Subject: Lochinvar CPSC Recall 20-141 – WH(N,L) Models – New Rework Kit 100335249

Figure 1.

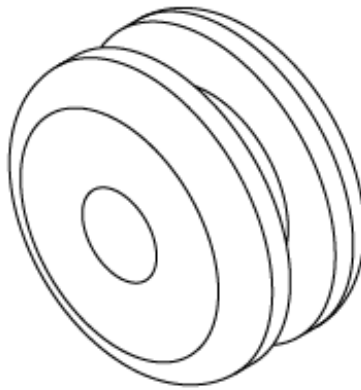
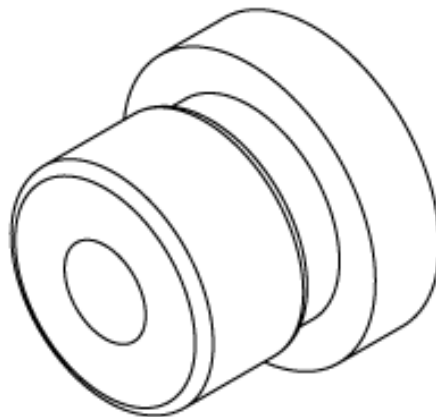
We have recently discovered that the flue grommet provided in the kit does not seal correctly and should not be used on **Knight WH(N,L) 056, 086, 111, 156, 200 & 286**.

Knight WH(N,L) 056, 086, 111, 156, 200 & 286 models were constructed with a schedule 40 CPVC internal flue which has a thicker cross section than the polypropylene material used on the other models subject to the recall. The replacement grommet provided with kit 100327911 was sized for polypropylene material, making it too small for the thicker CPVC flue. See the images of the grommets in the figures on the following page.

Grommet supplied with original kit number -100327911
DO NOT USE ON: WHN 056, 086, 111, 156, 200, 286

Lochinvar has therefore released **kit number 100335249**, which is now available for retrofitting **WH(N,L) 056 – 286** models. Please contact Lochinvar's Technical Service at **1-833-232-9706** to obtain this kit or answer any questions you may have.

Grommet supplied with new kit number - 100335249
For Use Only with: WHN 056, 086, 111, 156, 200, 286
